**SUPPLEMENTAL MEMORANDUM**

RE: Toll 44<sup>th</sup> Street NE Marysville – Response to City Comments  
(R.A.I. No. 2021-056-101)  
City of Marysville File No. PA22-024

This memorandum has been prepared in response to comments provided by the City of Marysville in a letter dated August 17, 2022 and via email on October 27, 2022 regarding the Wetland Delineation & Buffer Enhancement Plan for the Toll 44<sup>th</sup> Street NE project (Raedeke Associates, Inc. 2022).

**MITIGATION PLAN**  
**TOLL BROTHERS**  
**44TH STREET MARYSVILLE**  
**MARYSVILLE, WA**

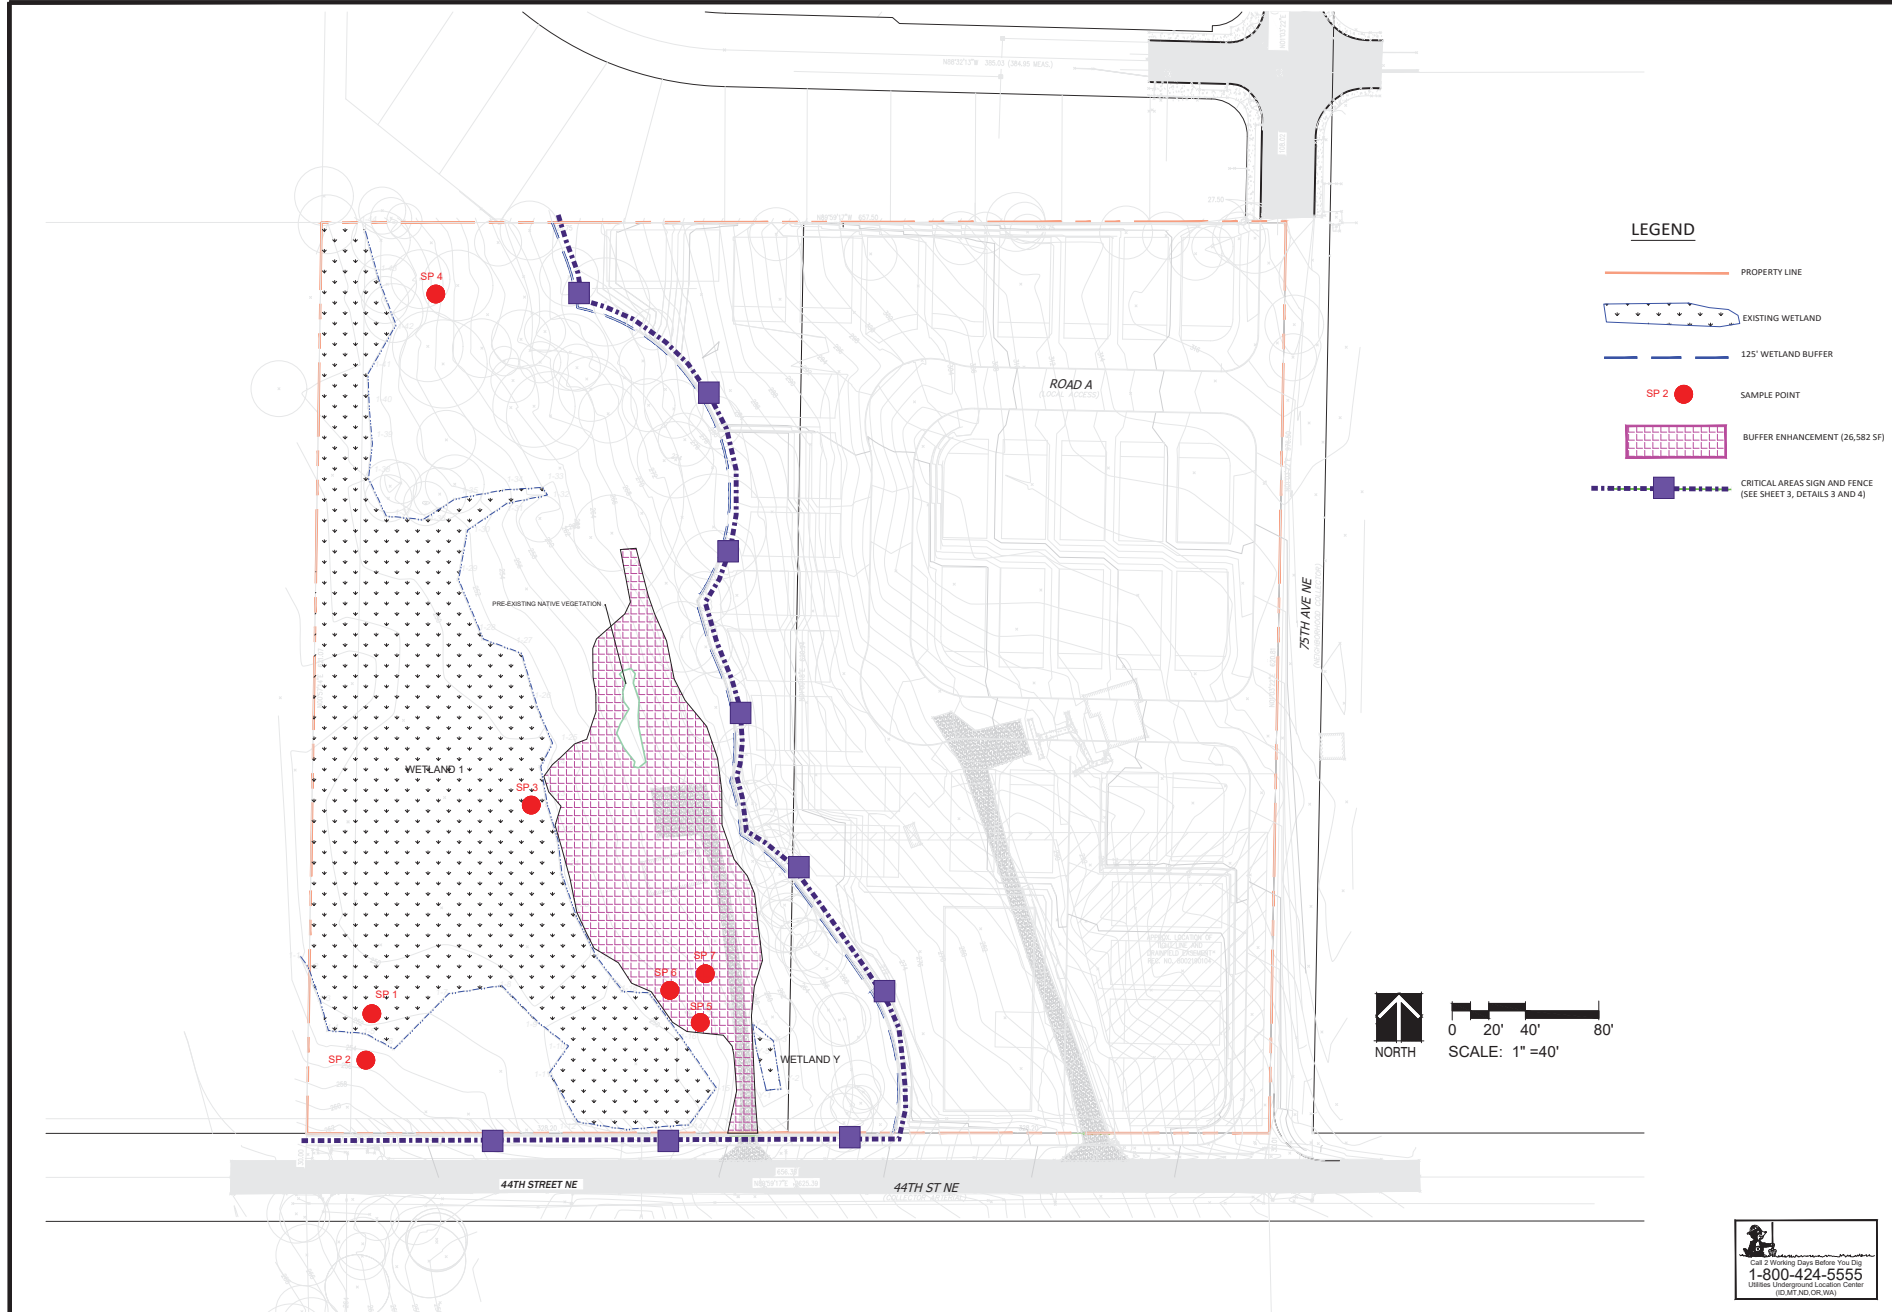
The buffer enhancement plan has been updated to show the split rail fence and critical area signage around the wetland buffer and along 44<sup>th</sup> Street NE (see Sheet 2 of attached sheets). The split rail fence may need to include openings or gates to allow maintenance access to the buffer enhancement area from 44<sup>th</sup> Street NE and openings where the split rail fence may intersect with any proposed trails.
